Access Compliance Report

Public Rights-of-Way

Intersection ID: 11506	Main Street: GRACE_ST	Cross Street: UNION_ST	Location: NE
ADA ID: 2190B55266BC	Ramp Type: BlendTrans2	Initial Pass/Fail: Fail	Overall Compliance: No
		Severity Score: 10

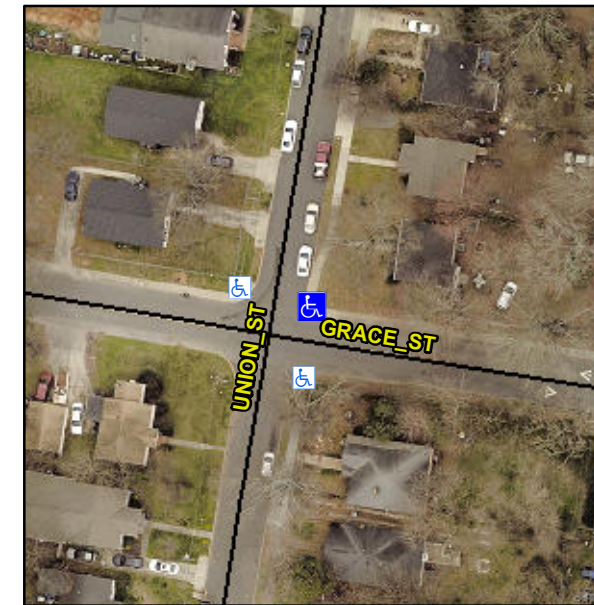
Compliance	Description	Data	Compliance	Description	Data
N/A	Ramp Length (in)	55.0	Yes	BlendTrans Slope (%)	4.4
No	Ramp Width (in)	46.0	No	BlendTrans XSlope (%)	3.8
N/A	Flare Type LT	N/A	N/A	Flare Type RT	N/A
N/A	Flare Slope LT (%)	N/A	N/A	Flare Slope RT (%)	N/A
N/A	Flare Traversable LT?	N/A	N/A	Flare Traversable RT?	N/A
N/A	Landing Length (in)	N/A	N/A	DWS Provided?	N/A
N/A	Landing Width (in)	N/A	N/A	DWS Contrast?	N/A
N/A	Landing Slope (%)	N/A	N/A	DWS Length (in)	N/A
N/A	Landing X Slope (%)	N/A	N/A	DWS Full Width?	N/A
N/A	Landing Curb? (Y/N)	N/A	N/A	DWS Offset (in)	N/A
N/A	Shared Landing?	N/A			
N/A	Gutter Ponding?	N/A	N/A	Gutter Slope (%)	N/A
N/A	Gutter Lip Ht (in)	0.5	N/A	Gutter X Slope (%)	N/A
N/A	Painted X Walk1?	No	N/A	Painted X Walk2?	No
	X Walk 1 Direction	To W		X Walk 2 Direction	To S
	X Walk 1 Width (in)	N/A		X Walk 2 Width (in)	N/A
	X Walk 1 Slope (%)	6.5		X Walk 2 Slope (%)	4.6
	X Walk 1 X Slope (%)	4.2		X Walk 2 X Slope (%)	5.8

Remove & Replace Curb Ramp With Two New Directional Ramps or Equivalent.
